Design & Access Statement – Summary of Design Changes

PROPOSED CARE HOME DEVELOPMENT

COLDHARBOUR ROAD, GRAVESEND

Version 01– Sep 2024

Site Plan, summary of Design Changes

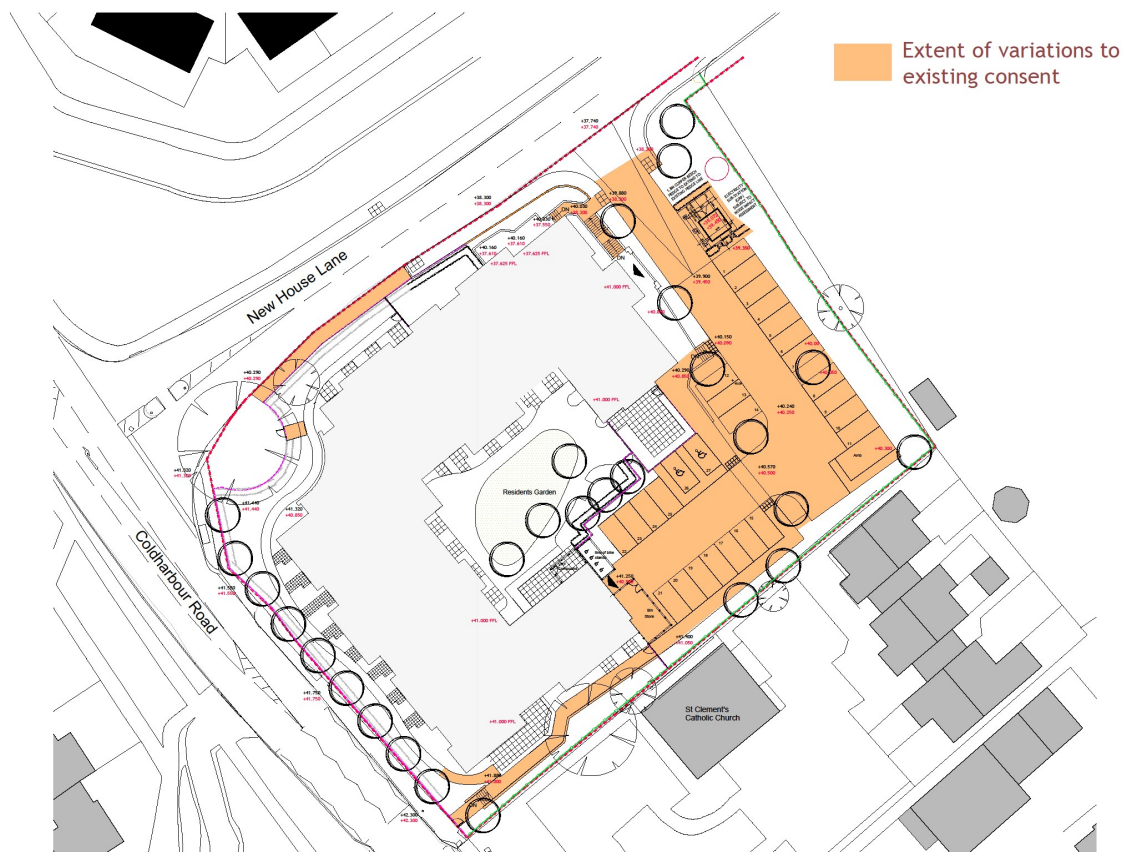
The site plan has been amended to include the substation in a location further into the site with screening from hedging along 3 sides.

Alongside this, the site levels have been amended from those in condition 12 Approved Site Levels Plan (ref. 3172-HIA-ZZ-XX-DR-A-0103) with the shallowing of the vehicular entrance slope and lowering of access path at south of site to allow access around building. These changing of levels have adapted the stairs and include provision of additional retaining walls.

A path has been introduced to the tree at the corner of Coldharbour Road and New House Lane for maintenance.

The hedge and fence line has been pushed back on New house Lane to that of the path leading to the crossing to the east, also in this area an additional fence has been added separating resident from staff rooms.
